Product Change Notification

PCN-PCC-245-2017

| Business Unit | Product Line Code | Type of Change | Action | Date of Issue |
|----------------------|-------------------|-----------------------------|-------------------------------|---------------|
| PCC - PCB Connectors | AAC | Product Change Notification | Notify Distributors and Field | 2/6/2017 |

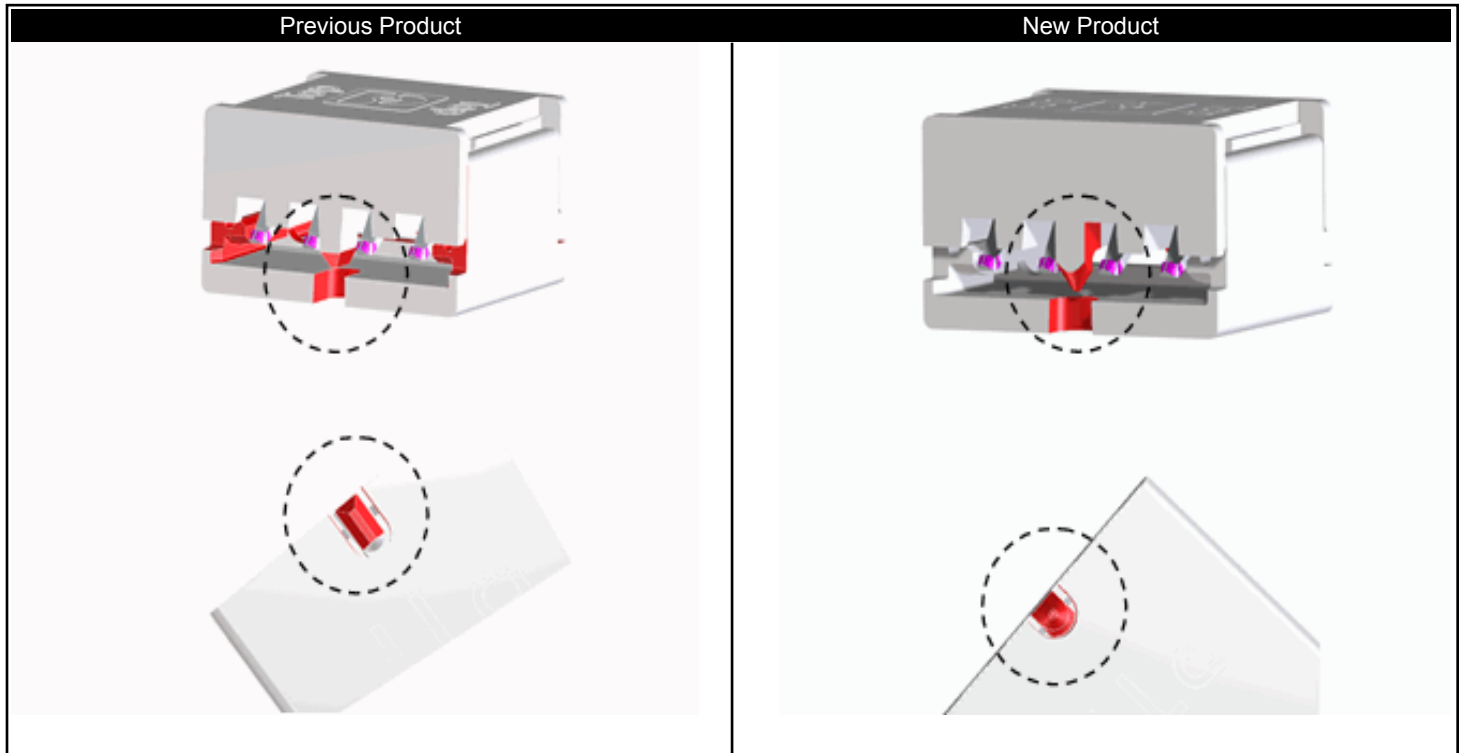
The piercing element on the PTF product line has a new shape. LED stripes are easier to penetrate with this shape. Dimensions and technical data remain the same. During the conversion period both versions will be delivered depending on the inventory. The molding tool for implementation has changed. The following product numbers have also been
